Downtown Subarea Plan Proposed Amendments:

The Downtown Subarea Plan can be seen: http://www.ci.bremerton.wa.us/371/Downtown or at the City of Bremerton website: www.ci.bremerton.wa.us: Home-Our Government-Community Development-Downtown. The following are proposed amendments to the Comprehensive Plan portions of the Downtown Subarea Plan.

Downtown Subarea Plan Proposed Amendments:

Downtown Subarea Plan Boundaries

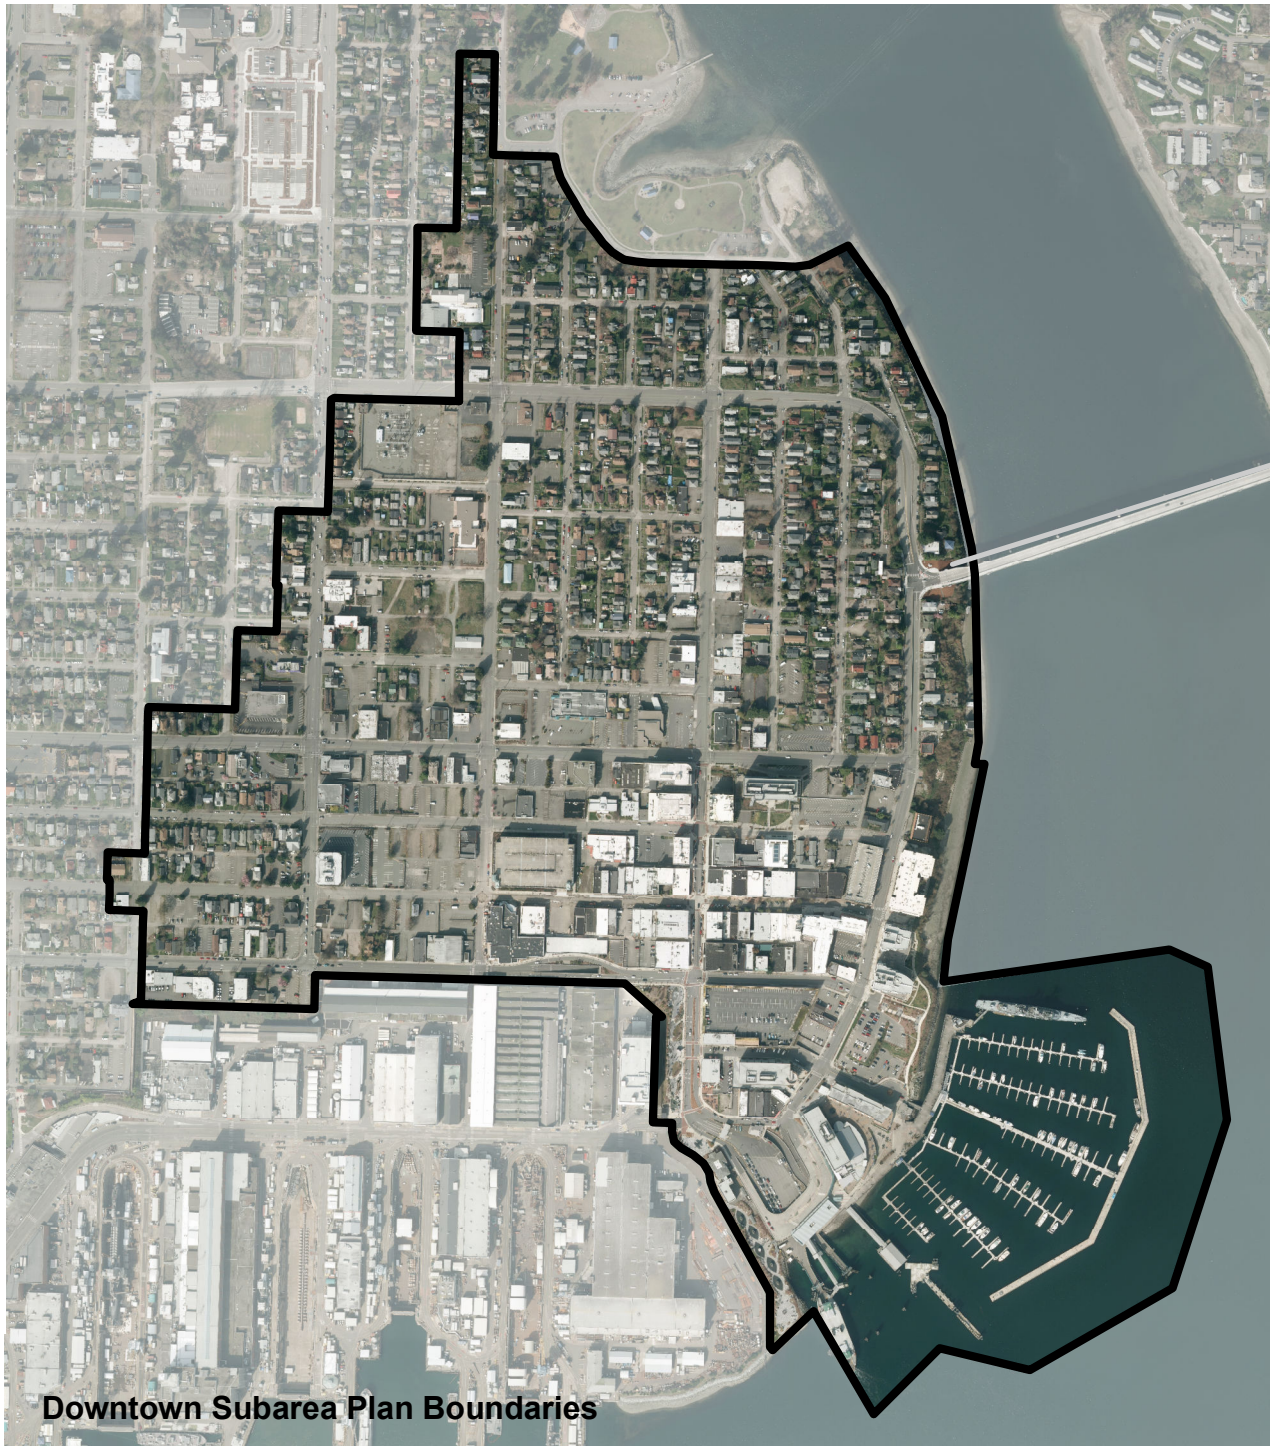
Page	Title or Figure for Proposed Revisions	Proposed Revisions to the Comprehensive Plan Portion	Other Information
Introduction: page I-5	1.0 Introduction, Purpose and Need; second paragraph	Revise second paragraph to reference 2016 Comprehensive Plan Update: "The Sub Area Plan supports and implements the policies presented in the 2004 and the updated 2016 City of Bremerton Comprehensive Plan…"	Updated to be current with Comprehensive Plan Update.
Introduction: page I-5	Downtown Subarea Study Area Boundaries Map	Revise map to provide additional area that was identified in the Comprehensive Plan Update.	This includes the area west of Warren Avenue between Burwell and 6th Streets. Replacement page has been included as **Exhibit 1.**

5.4 Street Typologies

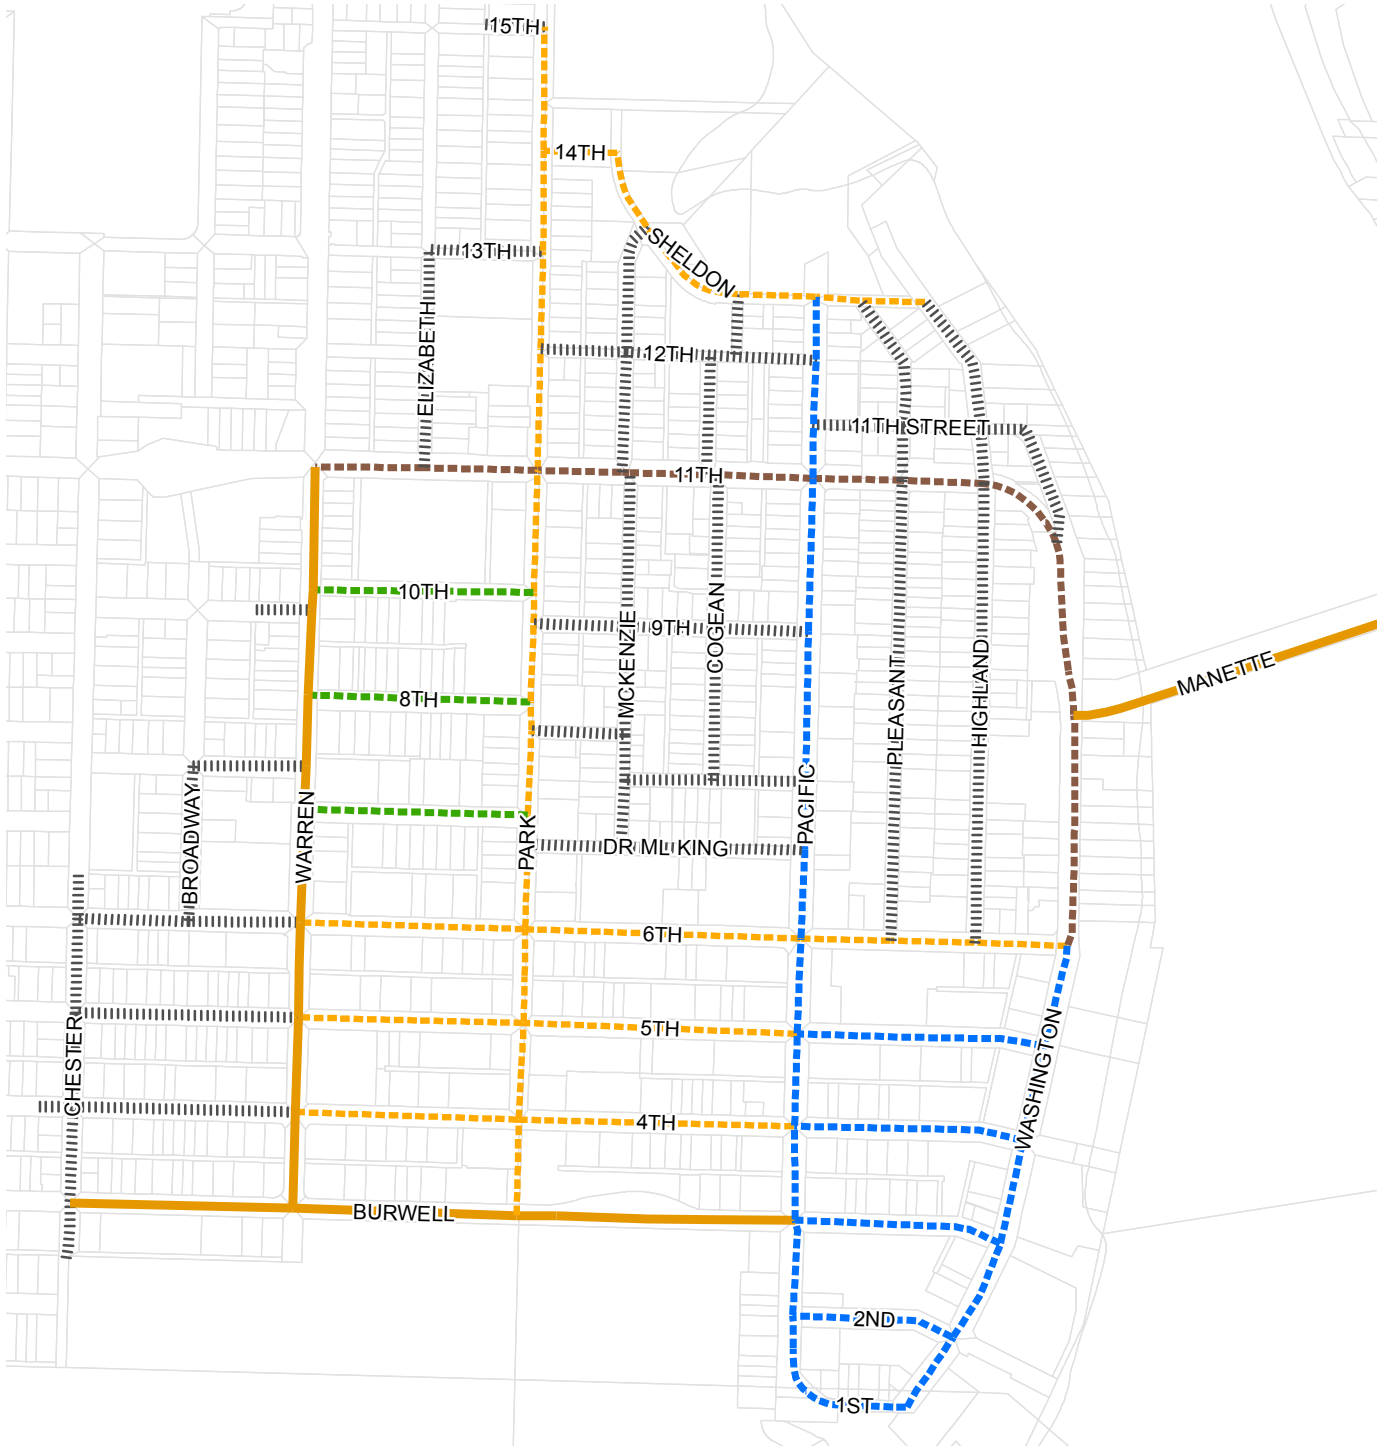
Page	Title or Figure for Proposed Revisions	Proposed Revisions to the Development Standards Portion	Other Information
Circulation: page 5-70	5.4 Street Typologies Map	(a) Revised map to include the street from the Center expansion proposed in the Comprehensive Plan Update. Street Typologies should be the following: Burwell Avenue is a Regional Arterial typology; and 4th Street, 5th Street, 6th Street, Chester Avenue, and Broadway Avenue are proposed as Residential Streets. (b) Include the following provision at the beginning of Street Typologies: In following sections of descriptions of street typologies, existing right-of-ways that do not meet the identified width for all improvements will be required to coordinate with Department Public Works and Utilities on appropriate streetscapes.	Replace page with revised map – it has been included as **Exhibit 1**. (b) This was an issue for a project that had an existing right of way that was 40' yet, the improvements required 60'. This provision will allow Staff to work within the Code.

figure 6.1

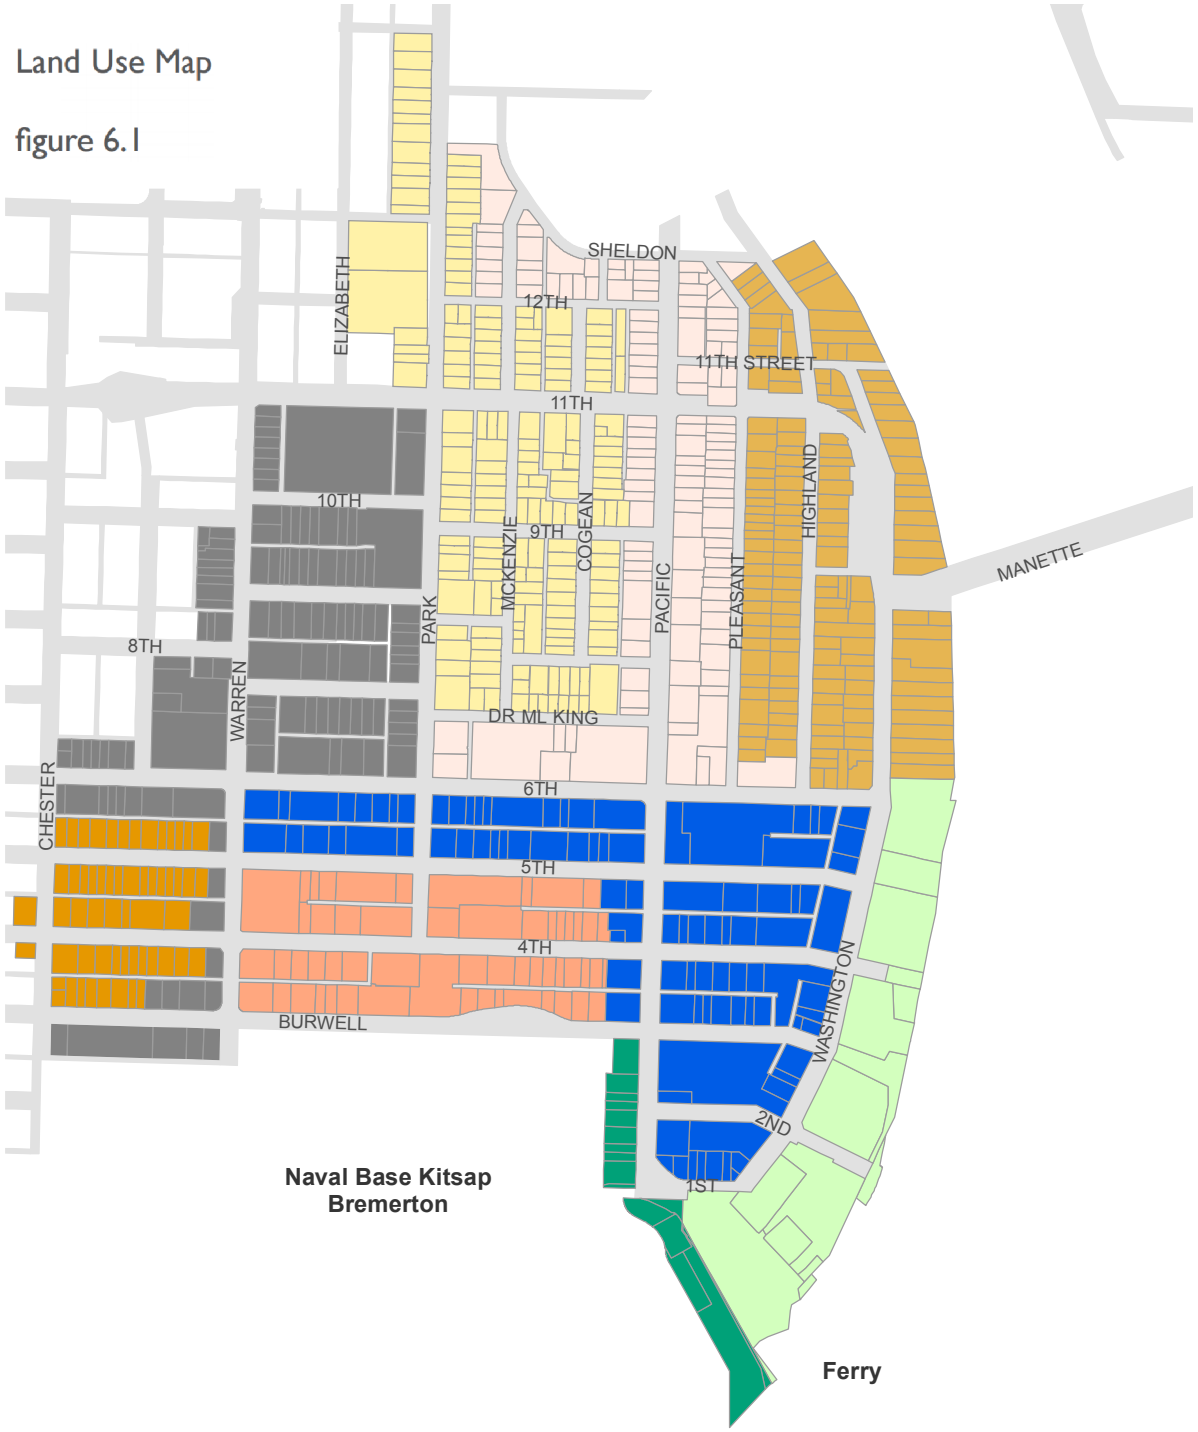
Circulation: page 5-76	Graphic image of "Green Streets" layout	Revise the total lineal feet of roadway from "~~40'~~" to "60'."	The number is incorrect and should be 60'.
Circulation: page 5-79	5.4.7 Street Typology Summary Table	Within the Primary Pedestrian column, under the Furniture row, it states that Newspaper boxes are allowed. That checkmark should be removed to not allow newspaper boxes on primary pedestrian roadways.	On page 5-75, the Pedestrian Primary Street identifies that "No newspaper boxes are allowed as street furniture." This will provide consistency within the code sections.
Development Standards: page 6-100	Land Use Map Figure 6.1	Revised map to include the additional Downtown Subarea Plan (DSAP) areas proposed in the Comprehensive Plan Update.	Replace page with revised map as **Exhibit 2**
